FINAL
Environmental Impact Report
Oak Hill Apartments Project
Unincorporated Marin County, California
State Clearinghouse Number 2022030718

SECTION 2: RESPONSES TO WRITTEN COMMENTS

III. Draft EIR Section 3.12 (Appendix I), and Alternatives 2 Through 5, Transportation and Ingress/Egress

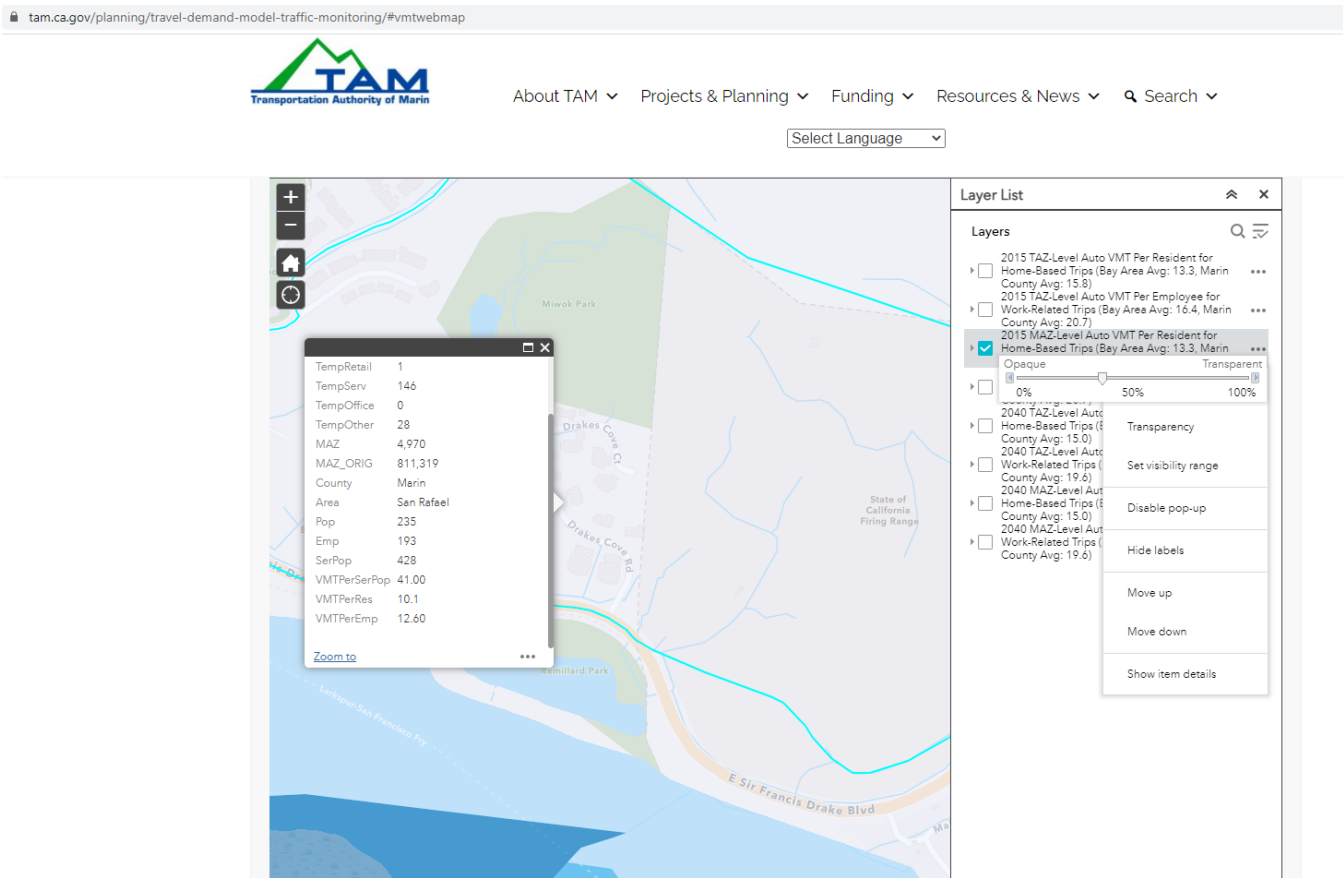
Section 3.12 and Appendix I, along with Alternatives 2-5, address traffic, ingress, and egress issues raised by the project. To be honest, this section and the supporting materials were very difficult to decipher, since they rely on multiple statistical models interacting with one another. I am a graduate of Berkeley Law and a member of the California Bar, and had a hard time following the analysis that concludes that there are no significant transportation impacts from adding 250 units and nearly 400 cars to a thoroughfare that is already clogged at peak hours. Apparently, what most people would consider to be common sense issues to evaluate, such as traffic bottlenecks and significant reductions in Level of Service (LOS) at affected intersections, are not actually relevant under new laws and regulations pertaining to CEQA. LOS reductions and traffic delays are excluded from consideration as significant impacts.

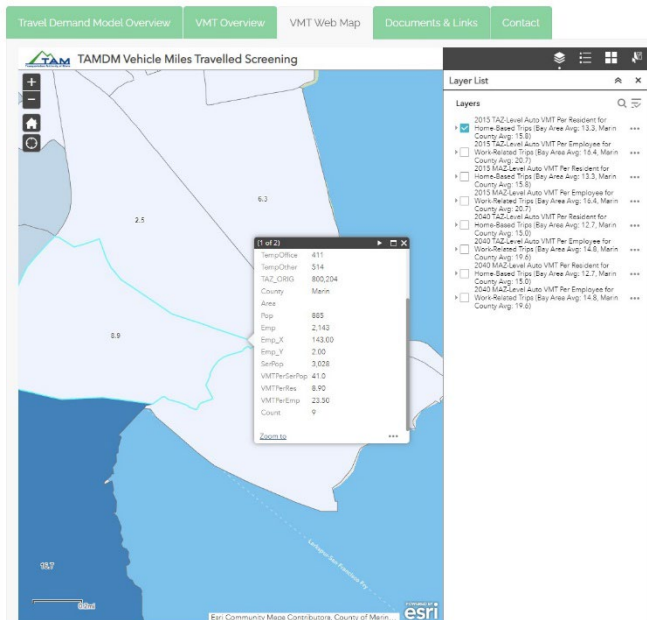
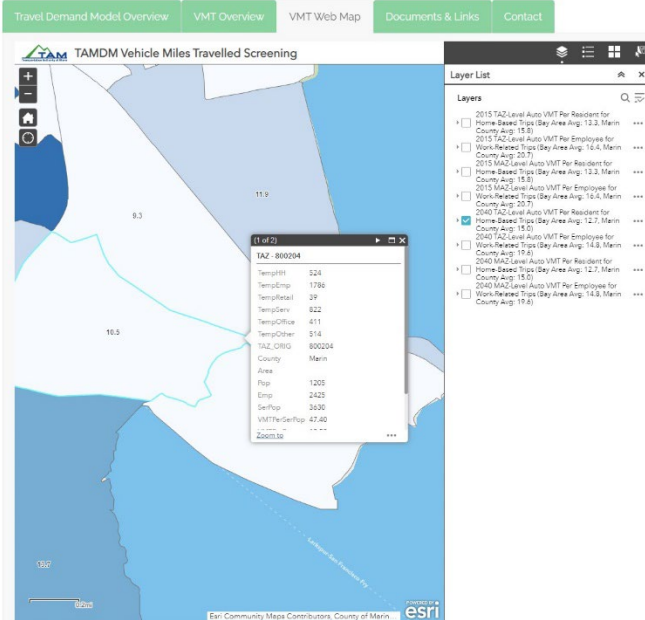
Ms. Rachel Krusenoski of FirstCarbon provided a working link to TAM's MAZ data, which has the project in MAZ 800,244, an MAZ which covers a larger area than the one depicted above. Below are the VMT calculations for MAZ 800,244, based on 2015 actual numbers (population 885, VMT 8.9) and a 2040 projection (population 1235, VMT 10.5). The project will significantly affect those population numbers, particularly in light of further expected development on the Ross Valley Sanitation District Parcel at the corner of Larkspur Landing Circle and East Sir Francis Drake Blvd.
